Middleby Cooking Systems Group

SUBJECT: Redesign of the High Flame Solenoid Valves for Middleby Marshall CE-approved gas-fired ovens.

Figure 1
High-Flame Solenoid Valves

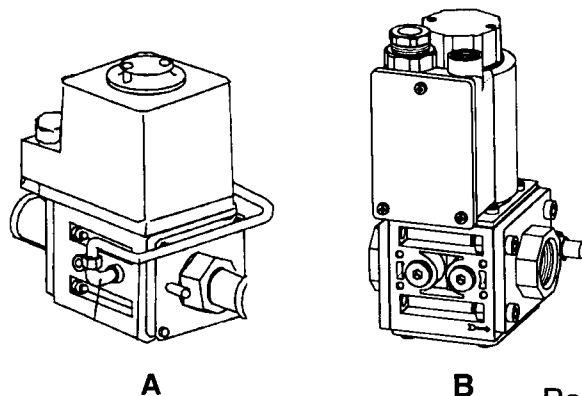
APPLICATION: When replacing a previous-style High Flame Solenoid Valve (Figure 1 item A) in a CE gas train with a current-style High Flame Solenoid Valve (Figure 1, item B), the wiring must be lengthened per the kit instructions to properly connect to the new solenoid. The existing gas pipe connections remain the same, because the new-style valve occupies the same position in the gas train as does the previous-style valve.

- A** Previous-style high-flame solenoid valve
- B** New-style high-flame solenoid valve
